**NC STATE UNIVERSITY**

Re: Technical Specifications Amendment 17  
License No. R-120  
Docket No. 50-297

Attached please find a response to the letter dated 23 October 2007 titled "Request for Additional Information Regarding Amendment 17 of Operating License R-120 for the North Carolina State University PULSTAR Reactor (TAC NO.MD4280). A response to each individual question is provided.

## RAI Number and Response

# VENTILATION AND RADIATION MONITORING SYSTEM DIAGRAM

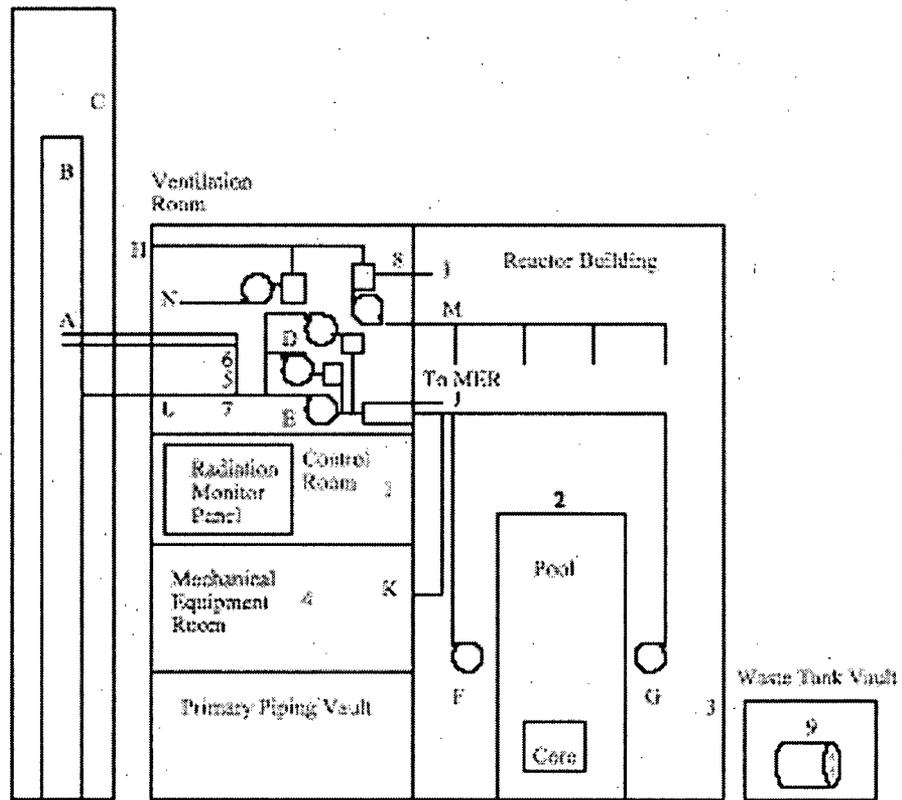
1. The ventilation exhaust flow rate with the new ventilation system is given as 1870 cfm.
  - a) Attachment B-1 shows a flow of 270 cfm into the exhaust plenum from an unidentified source. Is this source external to the reactor bay? If so, how are the fuel failure event durations, as calculated on page 49 of Appendix B, affected by the decreased reactor bay exhaust flow rate, and how does this affect off-site doses and AEC fractions? How are occupational accident doses affected by a longer reactor bay air exchange time?

- b) Attachment B-1 shows a flow of 200 cfm into the exhaust plenum from the BT&TC exhaust fan. Is this fan required to be running during accident scenarios? If not, how are the fuel failure event durations, as calculated on page 49 of Appendix B, affected by the decreased reactor bay exhaust flow rate, and how does this affect off-site doses and AEC fractions? How are occupational accident doses affected by a longer reactor bay air exchange time?

The ventilation system description provided in the amendment request was in error. Corrections are summarized below:

In the reactor building ventilation system, there is only one exhaust duct and only one exhaust fan in operation at a given time. For normal ventilation, the nominal fixed exhaust rate is 1870 cfm. In confinement mode, the nominal fixed exhaust rate is 600 cfm. The (Pneumatic) PN and (Beam Tube & Thermal Column) BT&TC fans are used to move air these systems or areas into the exhaust duct without entering the reactor bay. The PN and BT&TC fans do not increase the ventilation system exhaust rate. 270 cfm is the air return flow rate from the ventilation room.

The 270 cfm is the air return flow rate from the ventilation. This air flow has no effect on the fuel failure event duration, off-site doses, or AEC fractions calculated in Attachment 2. Attachment 2 used exhaust flow rates of 1870 cfm for normal ventilation and 600 cfm for confinement.

The 200 cfm is the input into the normal ventilation from the BT & TC if it is on. This fan is routinely used while the reactor is in operation and turned off upon reactor shutdown or initiation of confinement. If an accident occurs, this fan would have no effect on the accident analyses. Calculations given in Attachment 2 were performed at a normal ventilation exhaust rate of 1870 cfm and confinement exhaust rate of 600 cfm. Therefore, the calculations are not affected.

Figure 2.1-1: Power-Flow Safety Limit Curve

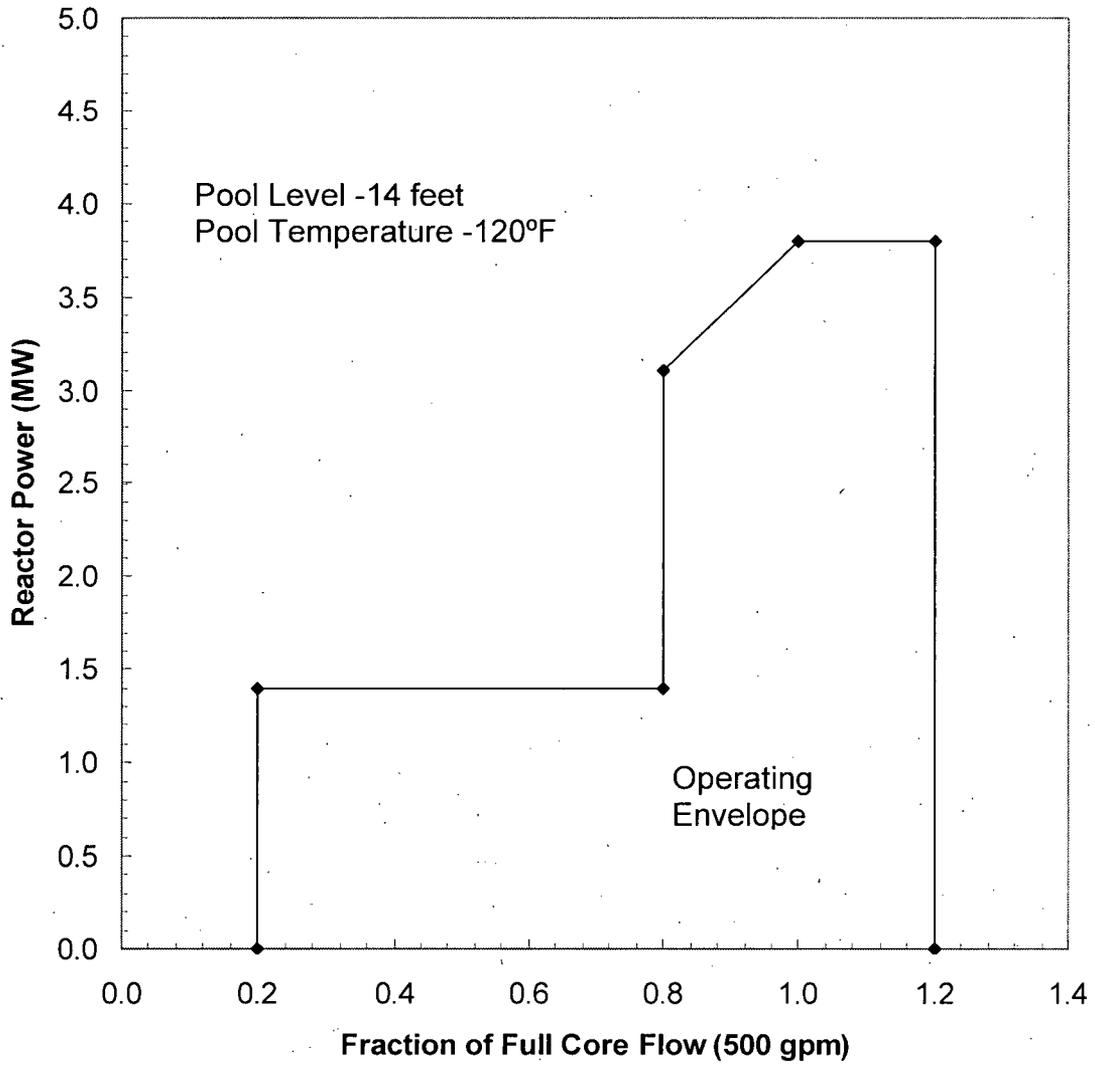
8. Figure 2.2-1, Power-Flow Safety Limit Curve

In the proposed TS this figure does not show the Operating Envelope as the same figure did in the previous version of TS. Also, in the proposed version of the figure the labeling does not specify the Safety Limit Specifications that the pool level shall be 14 feet or greater and the pool temperature shall not be greater than 120 °F. Since Specification 2.2.1.a. references the operating envelop in the figure the fact that it is missing may cause confusion. In addition, the title for the figure contains a typo with the word "full" rather than "flow." Please clarify your intentions with regard to the labeling on this figure.

This comment applies to Figure 2.1-1. The changes noted in this statement have been made to Figure 2.1-1 in the revised Technical Specification amendment.

**Figure 6.1-1: NCSU PULSTAR Reactor Organizational Chart**

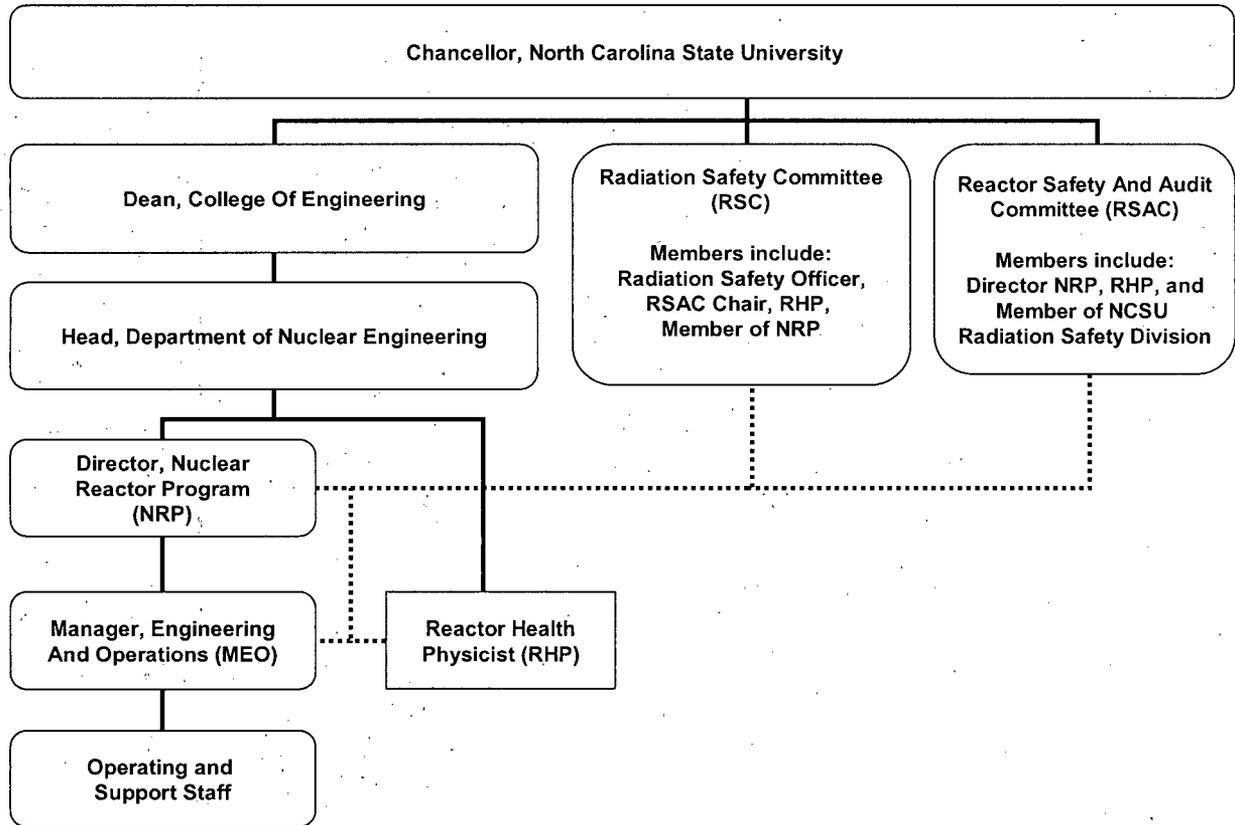
The advice and liaison lines have been removed with the proposed Figure 6.1-1. Provide discussion of the changes in the organizational structure. Include changes in responsibility, authority, and lines of communications, e.g. what are the interface inter relationships between the Reactor Health Physicist, the Nuclear reactor Program personnel, the Reactor Safety Committee, and the Reactor Safety and Audit Committee. Discuss the change from the Reactor Safety Committee reporting to the Reactor Safety and Audit Committee which in turn reports to the Chancellor and the proposed structure where they both report to the Chancellor independently. Discuss how the proposed changes will affect safety, independence, and oversight.

One change to Figure 6.1-1 is that it now shows the RSAC no longer reports to the RSC. This is reinforced by the removal of the statement that the RSC performs final review of the actions of the RSAC. Discuss the reason for that change and the safety implication.

Advice and liaison lines in Figure 6.1-1 have been added. The notes for Figure 6.1-1 have been changed to indicate direct communication and advice and liaison as follows:

Also, RSC and RSAC membership by positions knowledgeable of reactor operations and radiation safety have been added to Figure 6.1-1.

- RSC receives the audit report information from the RSAC.
- In the proposed TS, RSAC informs RSC of its actions and RSC and RSAC are allowed to communicate directly with each other. Furthermore, RSC may require additional actions by the RSAC or NRP. RSAC, RSC, and the RHP continue to be independent of the NRP as shown in Figure 6.1-1.
